## Task Force SAFE

**Inspection-Report\_TFSAFE\_Full\_KATAB\_29100-Warehouse-EXT\_128\_16-06-26\_1-4**

<b>Base Location</b>	KA2AB (Jordan)	<b>Date:</b>	16-JUN-2026
<b>Base Code</b>	KATAB	<b>Team #:</b>	128
<b>Building #</b>	29100-Warehouse-EXT	<b>System Voltage</b>	230/400
<b>Building Type</b>	OTHER	<b>Inspection Phase</b>	Full Inspection
<b>Previous Report #:</b>	N/A	<b>Work Order:</b>	TFS-KATAB-2026-00004

<b>Deficiency #1</b>	<b>RAC 2</b>	<b>Occurrences: 1</b>
----------------------	--------------	-----------------------

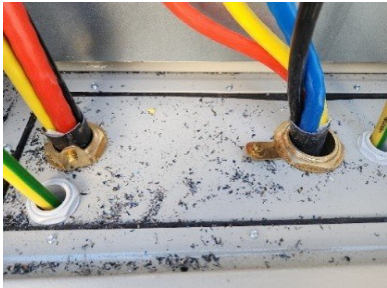
**Description:** Enclosure has not been bonded.

<b>Location:</b>	Within enclosure for isolator supplying air handling unit, south western corner.
<b>Category:</b>	Grounding and Bonding
<b>Equipment:</b>	WLT
<b>Imminent:</b>	No
<b>Action:</b>	N/A
<b>Assigned To:</b>	O&M; Provider
<b>Code:</b>	British Standard 542: Earthing arrangements
<b>Status:</b>	Closed / Repaired
